CITY OF ALBUQUERQUE

**RE: Kingdom Muay Thai
4471 Irving Blvd. NE
Grading and Drainage Plan
Engineer's Stamp Date: 6/7/24
Hydrology File: B13D035**

**WAIVER APPLICATION FROM STORMWATER
QUALITY VOLUME MANAGEMENT ON-SITE**

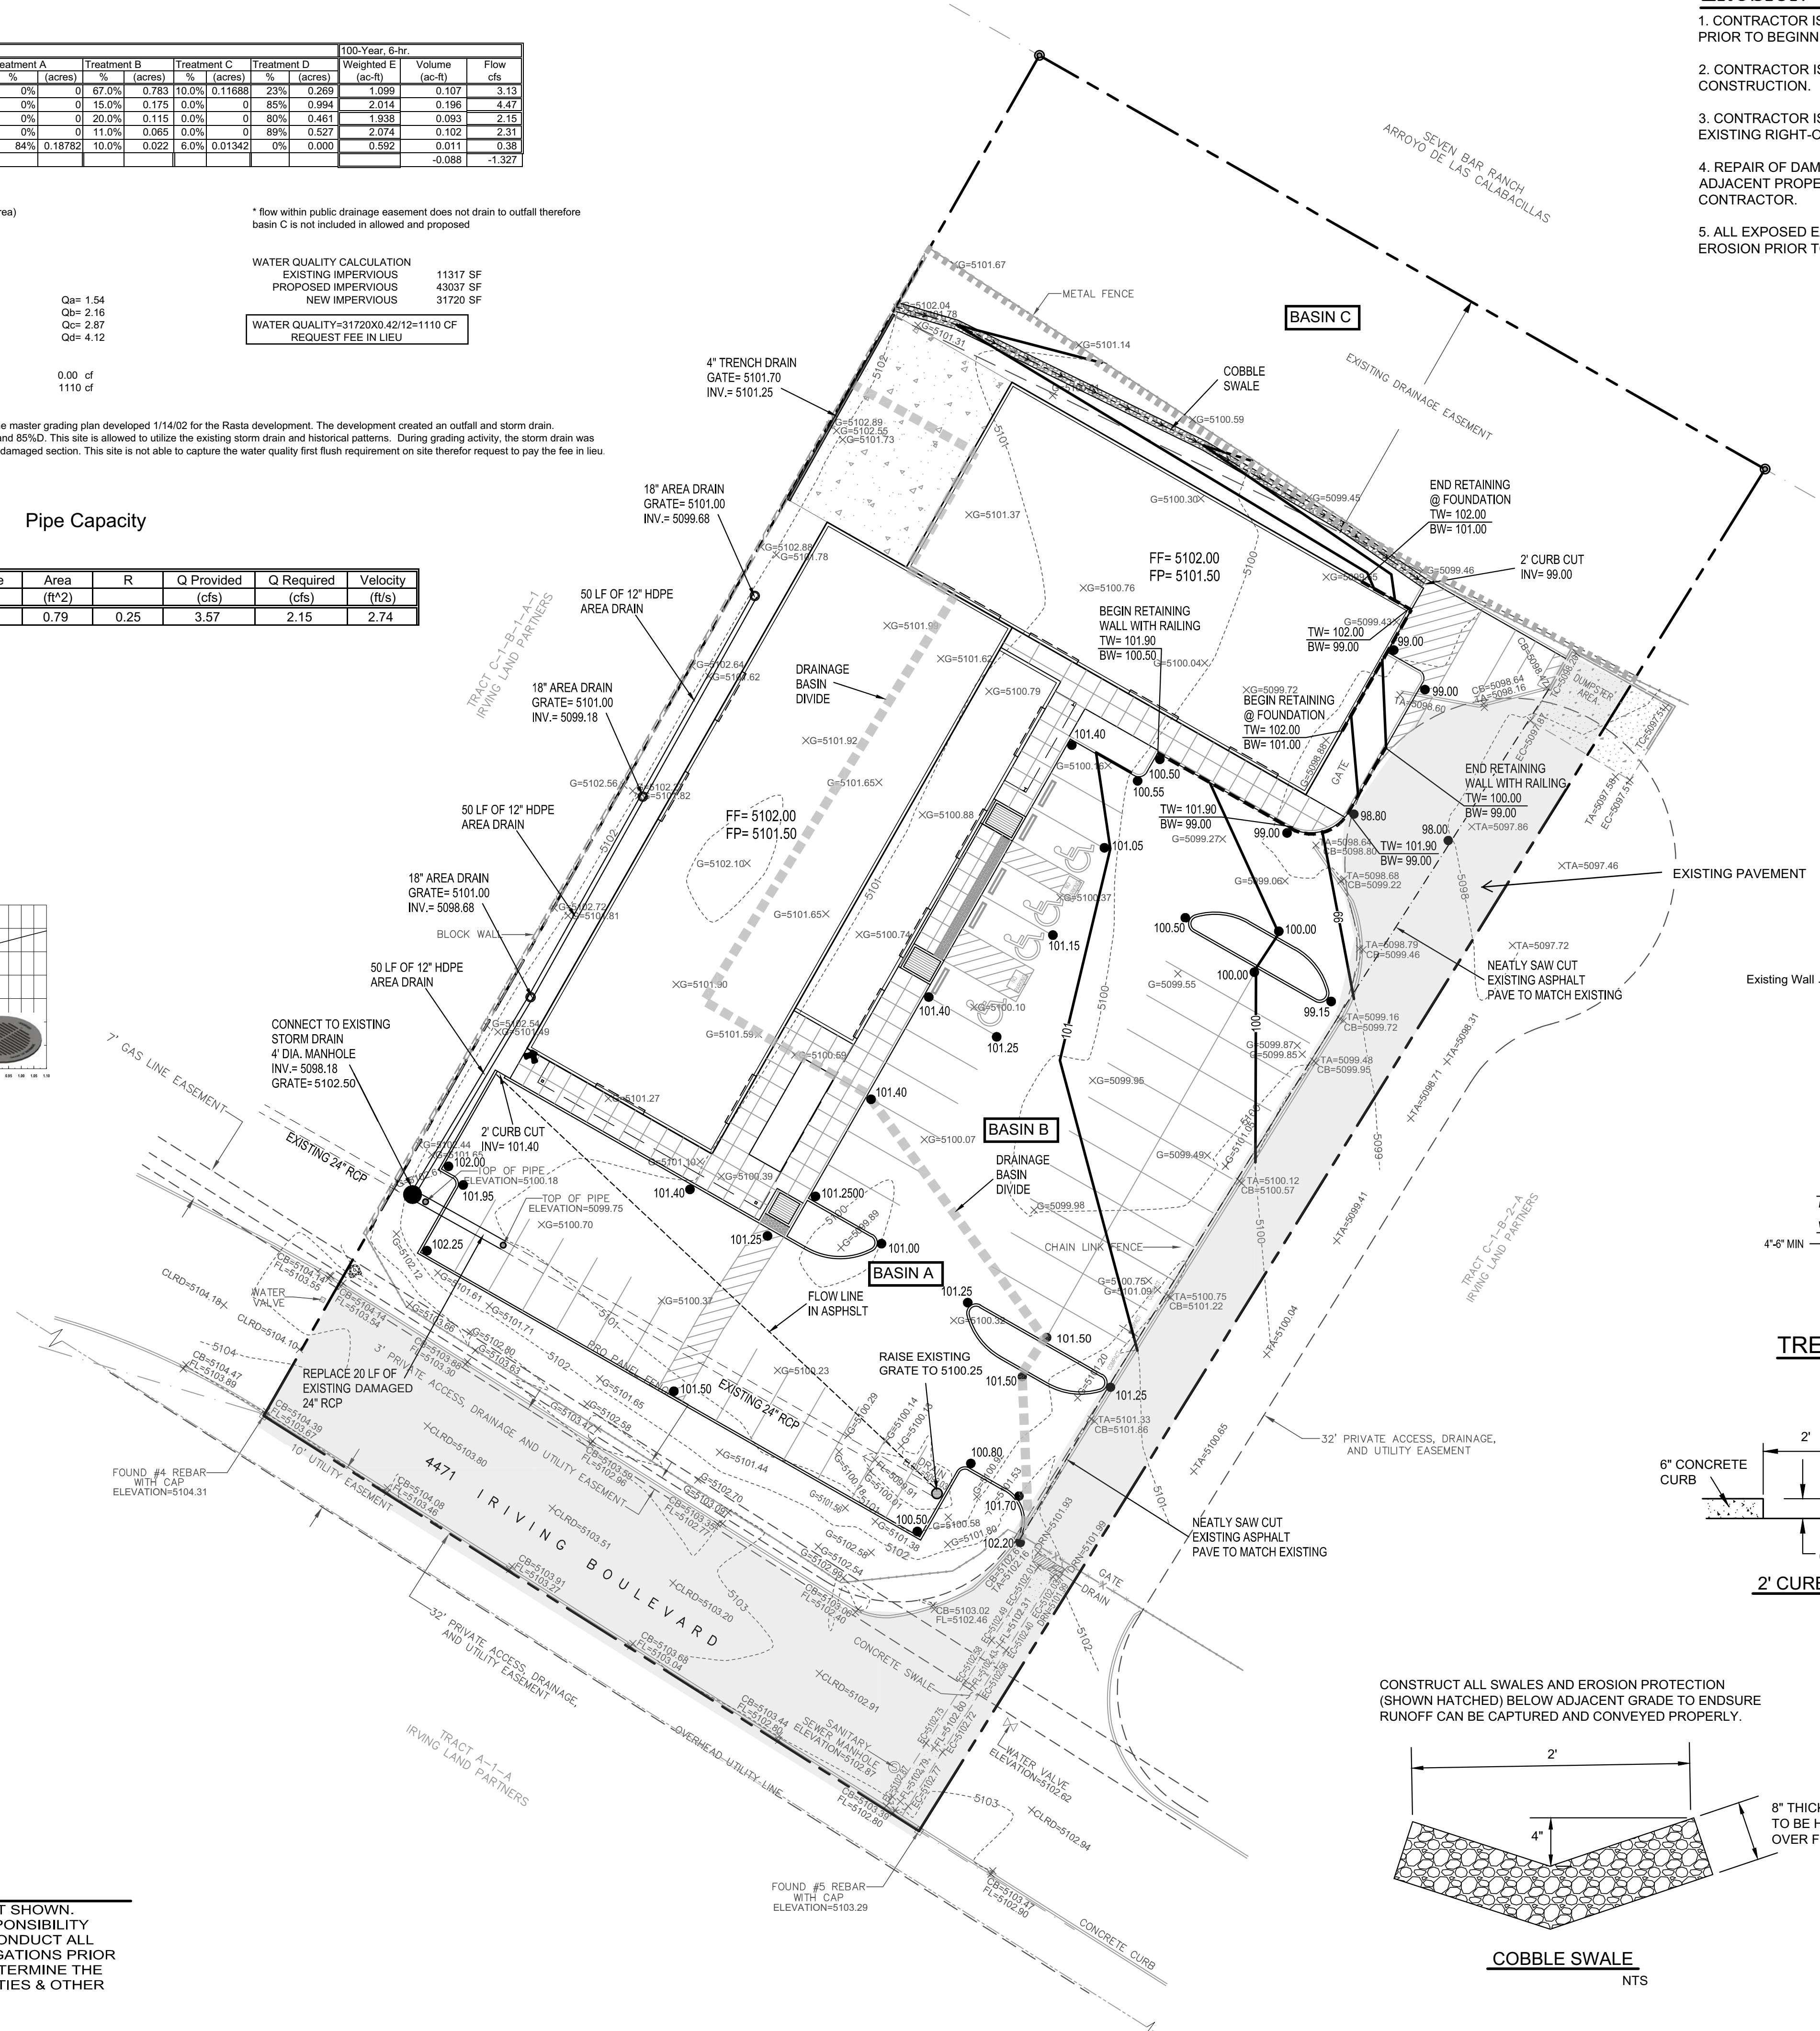
Based upon the information provided in your submittal received 06/07/2024, the Grading & Drainage Plan is approved for Building Permit and Grading Permit. Please attach a copy of this approved plan in the construction sets for Building Permit processing along with a copy of this letter.

1. Engineer's Certification, per the DPM Part 6-14 (F): *Engineer's Certification Checklist For Non-Subdivision* is required.
